Dell Avenue Solar Farm Site Plan & Special Use Permit – Comment Response Log Revision #2 (updates in red)

Dell Avenue Solar Farm Comment Response Log

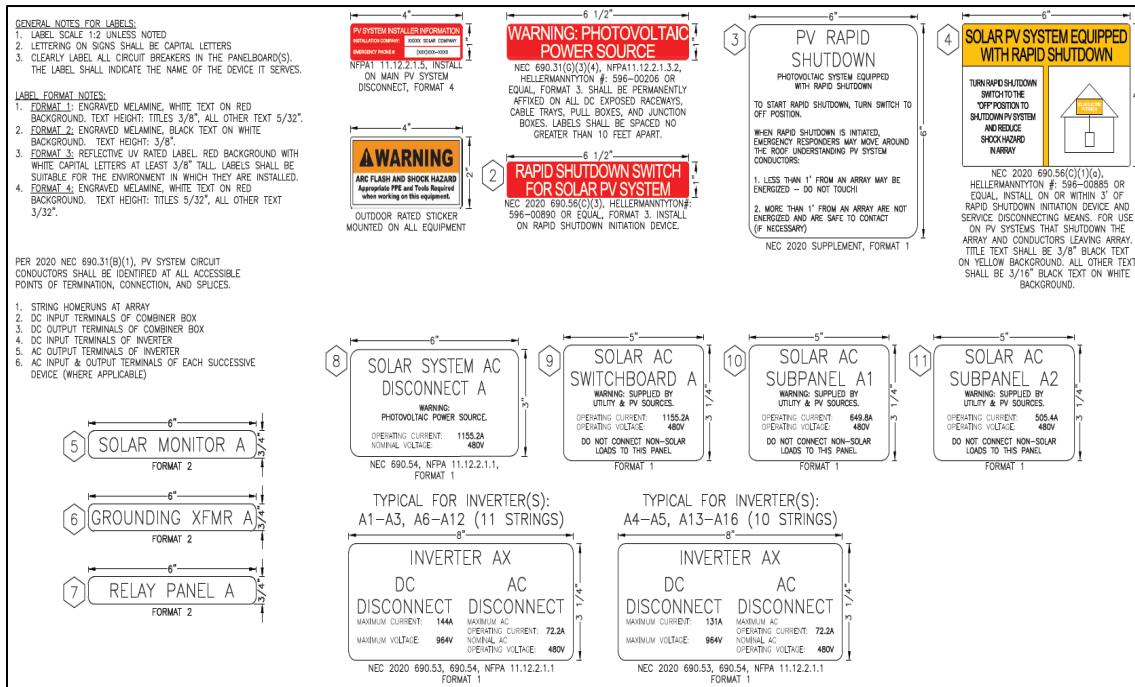
Compliant signage shall be provided throughout the installation including emergency contact information which shall be displayed on every access gate.

Upon receiving the Building Department Memorandum on Aug 02, 2022, an example photo of (compliant) emergency contact signage was shared with the Town of Yorktown Building & Fire Inspector via email and an affirmative response was replied. The photo and additional example signage is included below. These are not typically finalized this early in the project development phase, and therefore are not intended to be included in the Site Plan Set, but they are a requirement for all Sol Customer Solutions projects. The applicant fully agrees to the request for compliant signage to be provided throughout the facility, including emergency contact information displayed at both access gates.
